APPENDIX J
PUBLIC COMMENTS AND RESPONSES

RE: Comments On Draft Programmatic Environmental Assessment For 80 Acre Infill Oil and Gas Development On The Southern Ute Indian Reservation.

Re: Draft Programmatic Environmental Assessment
80-Acre Infill Oil and Gas Development
Southern Ute Indian Reservation (No CEQ #)

Figure 1. Ozone Design Values in the Four Corners Area for Different Emission Scenarios as Part of the SUI PEA.

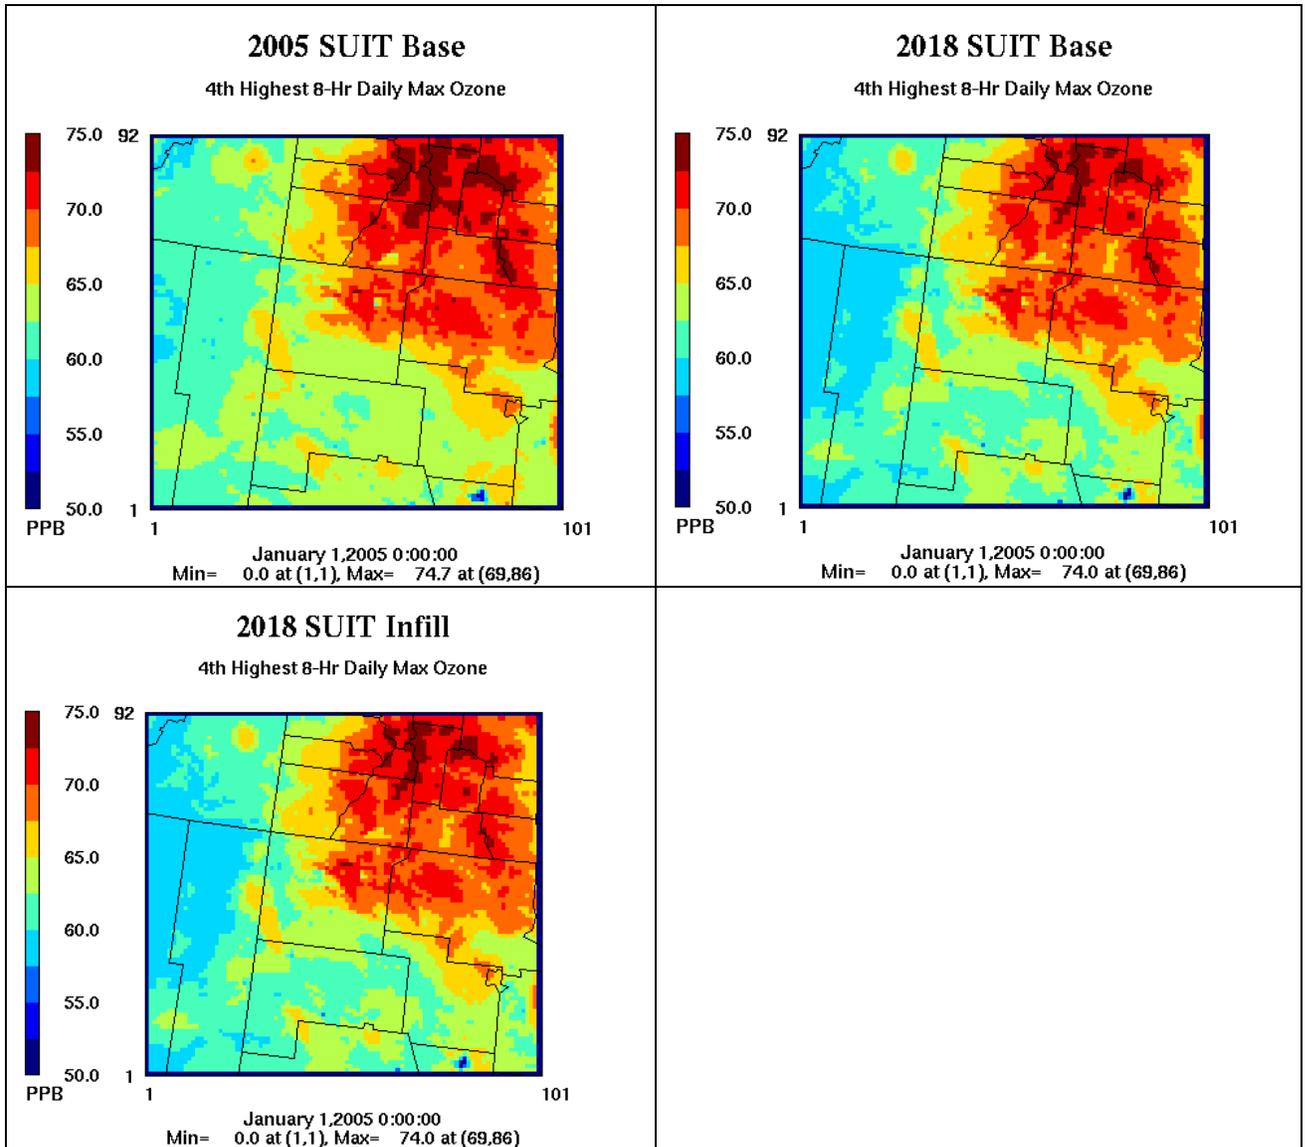
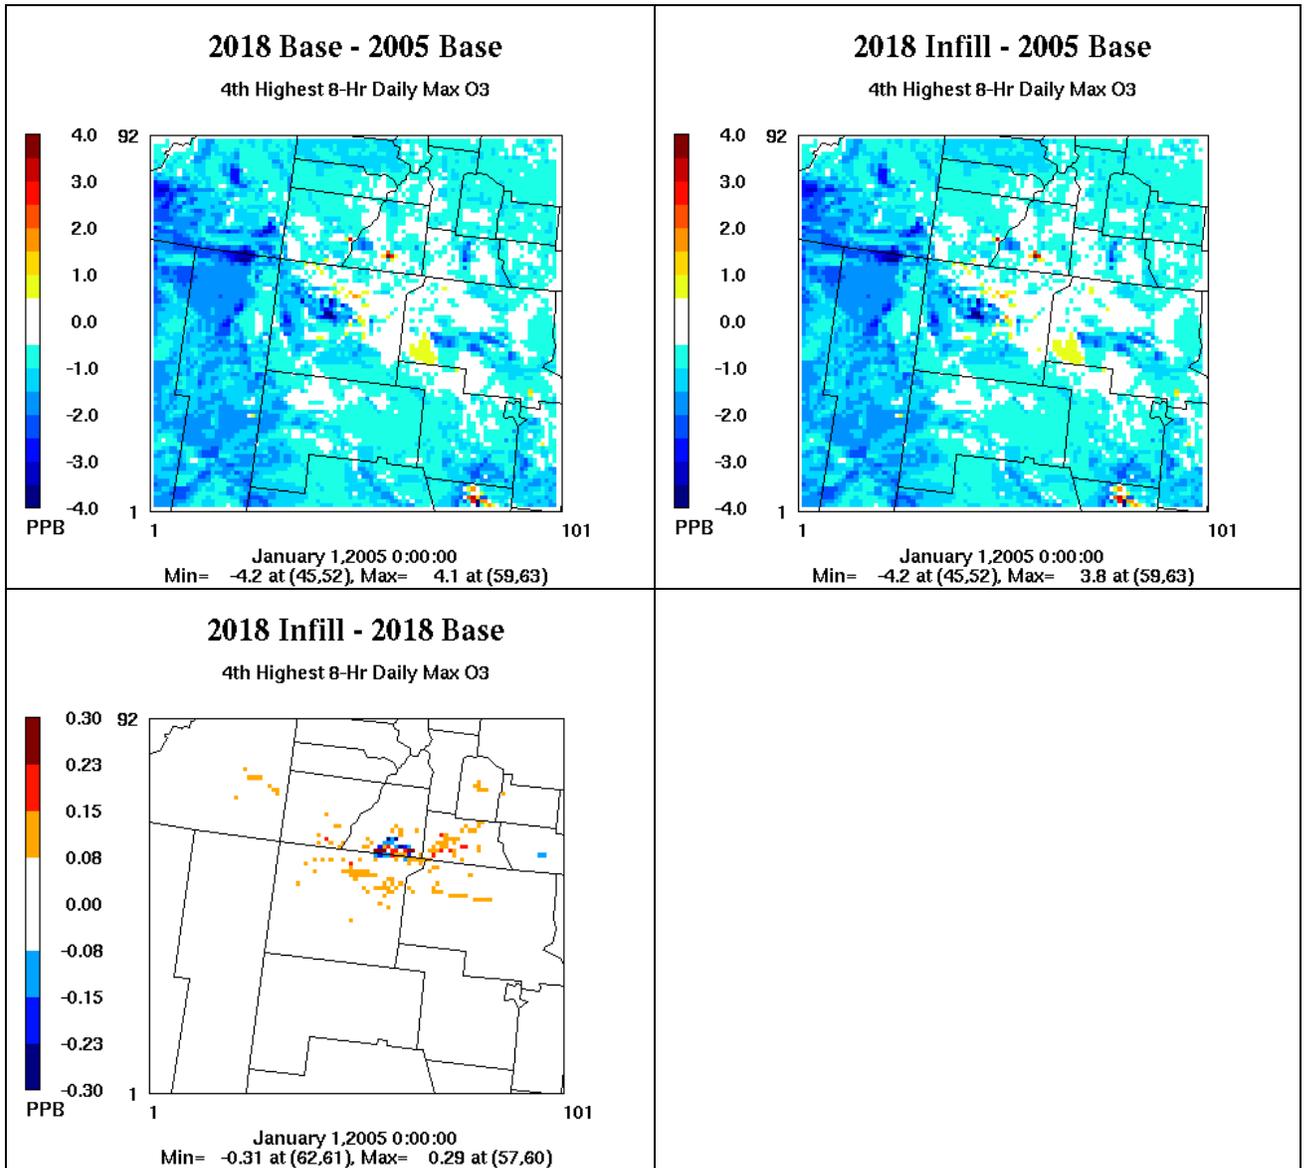
- 1) Absolute ozone modeled results for the various modeling scenarios should be presented in the Final PEA. Values should be presented graphically in maps for the entire domain.

- 2) Location information for the maximum incremental ozone modeled results for the various modeling scenarios should be presented in the Final PEA. Values should be presented graphically in maps for the entire domain.

EPA, General Air Quality Technical Comment-1: "The AEROMOD model was used..."	<p>Text changes and a table were added to PEA Section 4.2.5.</p> <p>The TSD presented PM10 and PM2.5 impacts from construction. The PM10 modeling was originally performed as part of the 1999 SUIT EIS using construction emission inventories and the EPA ISC dispersion model. As part of the PEA, PM2.5 emissions were developed from construction activities. PM2.5 impacts were then computed by ratioing the ISC PM10 construction modeling results by the ratio of PM2.5 to PM10 emissions.</p>
EPA General Air Quality Technical Comment-2: "The CAMx model was used to quantify..."	<p>Changes were made to the text in PEA Section 4.2.7 and in TSD Appendix G Section 7.2.1.</p> <p>The following figures present predicted ozone design values (annual fourth highest daily maximum 8-hour average concentration) in each 4 x 4 km model surface grid cell over the 4 km modeling domain (NM, CO, AZ, UT state and county boundaries are shown in each map). Figure 1 (see end of this comment table) presents design values for the 2005 base case, the 2018 base case (no action) and the 2018 full infill scenario (proposed action).</p> <p>Figure 2 presents the difference in design values between the 2018 base case (no action) and the 2005 base case, the 2018 full infill scenario and the 2005 base case and the difference between no action and full infill scenario. (Day on which design values shown in top two figures occurs varies from one grid cell to the next, thus these maps represent a composite of many days. As a result, design values from which the differences shown in Figure 2 are computed are not matched in time. For example, the 2018 full infill scenario design value may occur on a different date than the 2018 base</p>

Comment Number and Beginning Phrase	Responses to Comments
	<p>case design value in any given grid cell and the two dates can differ from one grid cell to the next.) The difference plots are not paired in time. (Day on which design values shown in top two figures occurs varies from one grid cell to the next, thus these maps represent a composite of many days. As a result, design values from which the differences shown in Figure 2 are computed are not matched in time. For example, the 2018 full infill scenario design value may occur on a different date than the 2018 base case design value in any given grid cell and the two dates can differ from one grid cell to the next.) Several important conclusions can be reached from the difference plots. First, for the 2018 minus 2005 base case there is a general reduction in predicted ozone design values over the region. The same trend is observed for the difference between the 2018 infill development and the 2005 base case. The maximum predicted increase in design value for the 2018 infill case minus the 2018 no action is 0.03 ppb as indicated by the dark brown shaded cells just north of the AZ – CO border. In addition, over the majority of the modeling domain differences in predicted ozone design values between these two scenarios are negligible (less than ± 0.08 ppb).</p>

<p>EPA, Specific Air Comments – 4: “Absolute ozone modeled results for the various...”</p>	<p>See EPA General Air Quality Technical Comment 2 above.</p>
<p>EPA, Specific Air Comments-5: “Location information for the maximum incremental ozone...”</p>	<p>See EPA General Air Quality Technical Comment 2 above.</p>
<p>EPA, Specific Air Comments-6: “While the</p>	<p>Comment noted – no changes in text.</p> <p>This programmatic NEPA document forecasts anticipated gas field compression</p>
